Revolution counter for ROTAX 447 SCDI

This Service Information makes Service Information 7 UL 91-E for Type 447 UL SCDI void.

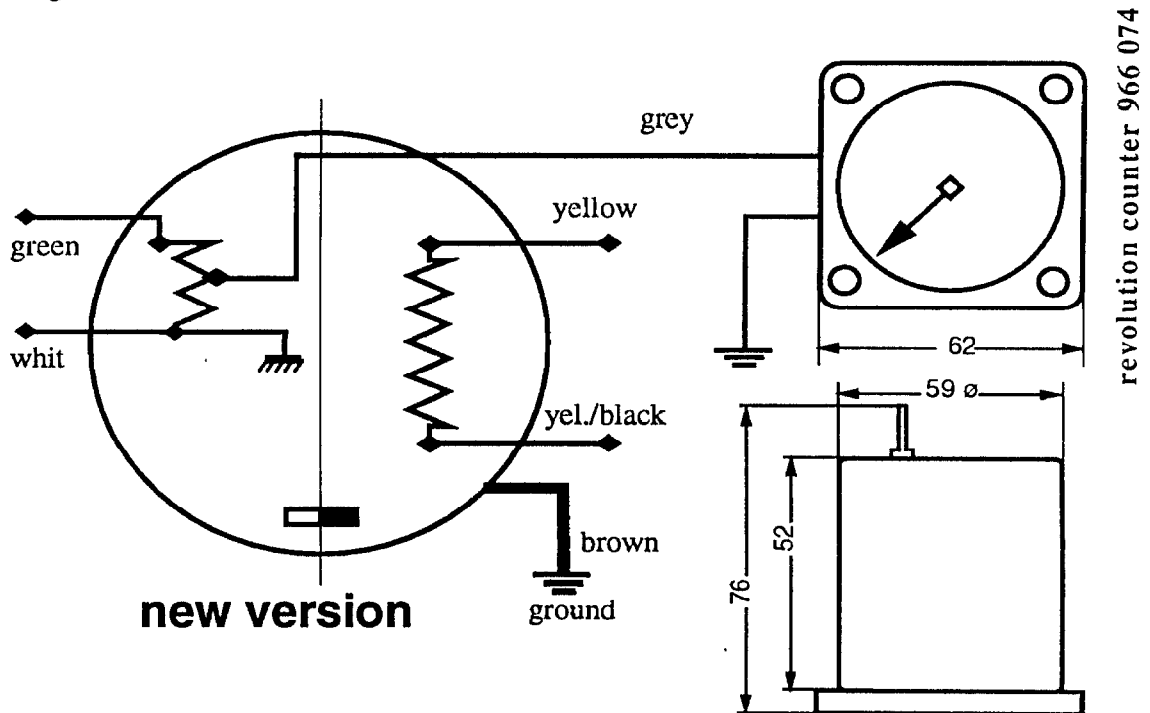
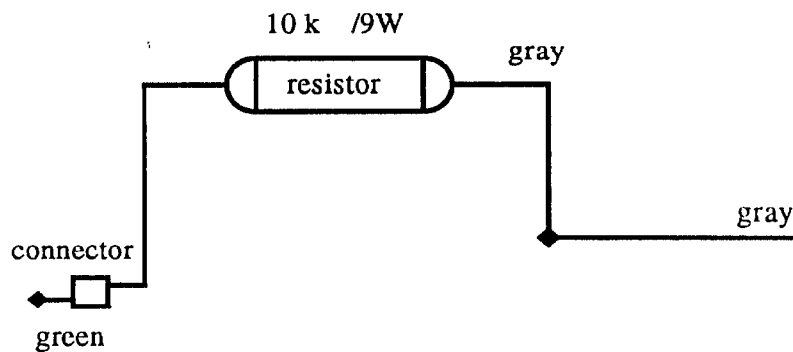
This information refers only to ROTAX 447 UL engines with electronic SCDI (single capacitor discharge) ignition . With introduction of magneto generator (ROTAX part no. 996 833) as of engine no. 3,910.411 no additional resistor is necessary for operation of the electronic tachometer (ROTAX part no. 966 074). The tachometer is connected directly to the gray cable.

◆ Note: As shown in the wiring diagram, no additional external current supply is necessary. Never connect the tachometer directly to an ignition circuit or to the lighting coil, but only to the central tapping wire (gray) of the charging coil.
